Recall Bulletin

PRODUCT EMISSION RECALL

SUBJECT: Degraded Connection between Ignition Coil Spark Plug Boots and Spark Plugs

MODELS: 2009-2011 Chevrolet Aveo
2009-2010 Pontiac G3/Wave
Equipped with a 1.6L Gas Engine (LXV)

2733897

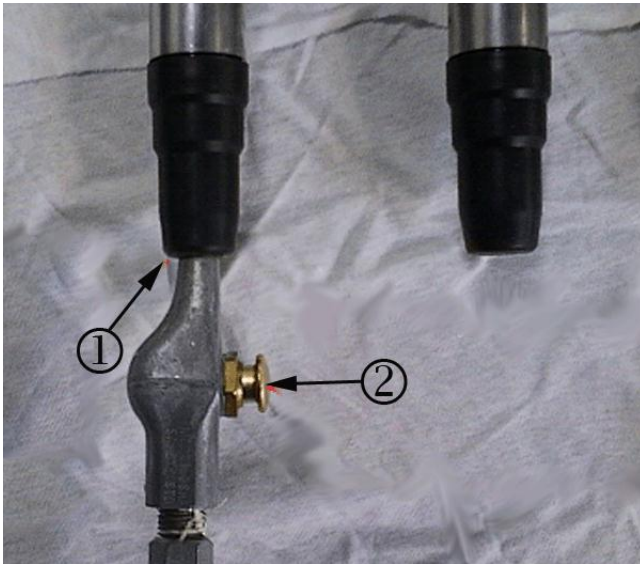
1. Remove the ignition coil assembly. Refer to *Ignition Coil Replacement* in SI.
2. Remove the spark plugs. Refer to *Spark Plug Replacement* in SI.
3. Install the four new spark plugs included in the spark plug kit.

Tighten the spark plug to 25~30 N·m (18.4 ~ 22.1 lb-ft).

3459357

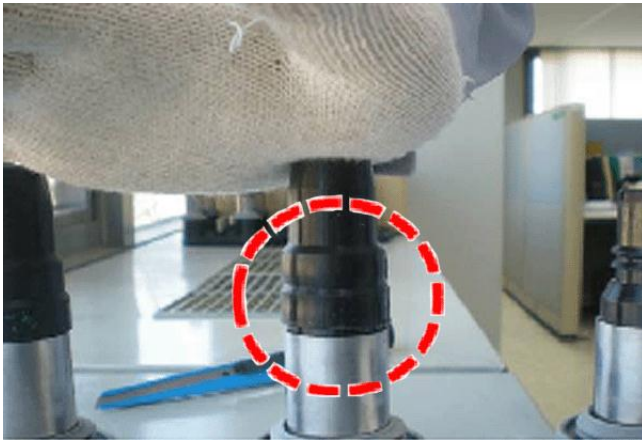
4. Place the removed ignition coil on table.

Caution: To avoid part damage, remove boots with coils in the horizontal position. Install new springs and boots with coils pointing up to ensure the spring stays in the coil and is centered. The new boot is fully seated when it is within 1 mm (0.040 inch) of metal shield.

5. Insert compressed air nozzle (1) into the boot. Ensure the air nozzle is inserted in the boot enough to form a tight seal between the air nozzle and boot.
